Access Compliance Report

Public Rights-of-Way

Intersection ID: 10019921	Main Street: ARDREY_KELL_RD	Cross Street: N/A	Location: NW
ADA ID: 82F3D4E636E3	Ramp Type: BlendTrans2	Initial Pass/Fail: Fail	Overall Compliance: No
		Severity Score: 8.75

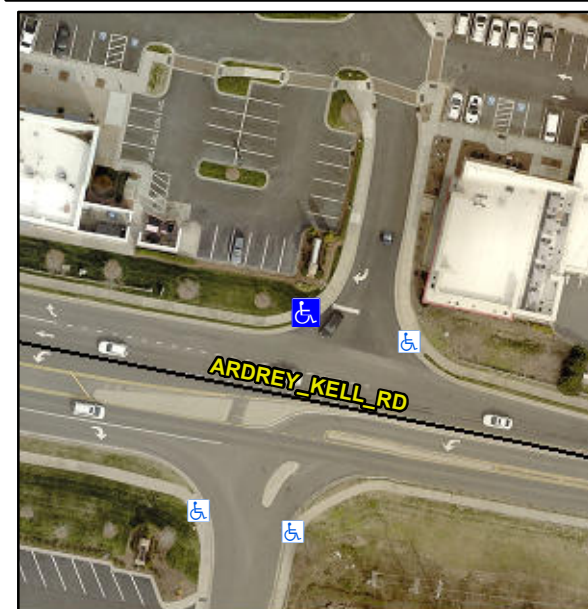
Not Found, R304.5.1

Compliance	Description	Data	Compliance	Description	Data
N/A	Ramp Length (in)	80.0	Yes	BlendTrans Slope (%)	4.3
No	Ramp Width (in)	47.0	Yes	BlendTrans XSlope (%)	1.6
N/A	Flare Type LT	N/A	N/A	Flare Type RT	N/A
N/A	Flare Slope LT (%)	N/A	N/A	Flare Slope RT (%)	N/A
N/A	Flare Traversable LT?	N/A	N/A	Flare Traversable RT?	N/A
N/A	Landing Length (in)	N/A	N/A	DWS Provided?	N/A
N/A	Landing Width (in)	N/A	N/A	DWS Contrast?	N/A
N/A	Landing Slope (%)	N/A	N/A	DWS Length (in)	N/A
N/A	Landing X Slope (%)	N/A	N/A	DWS Full Width?	N/A
N/A	Landing Curb? (Y/N)	N/A	N/A	DWS Offset (in)	N/A
N/A	Shared Landing?	N/A			
N/A	Gutter Ponding?	N/A	N/A	Gutter Slope (%)	N/A
N/A	Gutter Lip Ht (in)	N/A	N/A	Gutter X Slope (%)	N/A
N/A	Painted X Walk1?	No	N/A	Painted X Walk2?	N/A
	X Walk 1 Direction	To E		X Walk 2 Direction	N/A
	X Walk 1 Width (in)	N/A		X Walk 2 Width (in)	N/A
	X Walk 1 Slope (%)	2.4		X Walk 2 Slope (%)	N/A
	X Walk 1 X Slope (%)	1.0		X Walk 2 X Slope (%)	N/A

N/A	Ramp inside XWalk1?	N/A	N/A	Ramp inside XWalk2?	N/A
	Road Slope (%)	1.0		Clear Space?	N/A
	Road X Slope (%)	2.4	N/A	Clear Space to XWalk (in)	N/A
N/A	Any Obstructions?	N/A	N/A	Storm Grate/Utility Hazard?	N/A
	Obstruction Type			Storm Grate/Utility Type	
		N/A			N/A
			Yes	Surface Condition? (G/P)	Good
			No	Curb Slope (%)	19.3

Remove & Replace Curb Ramp With Two New Directional Ramps or Equivalent.
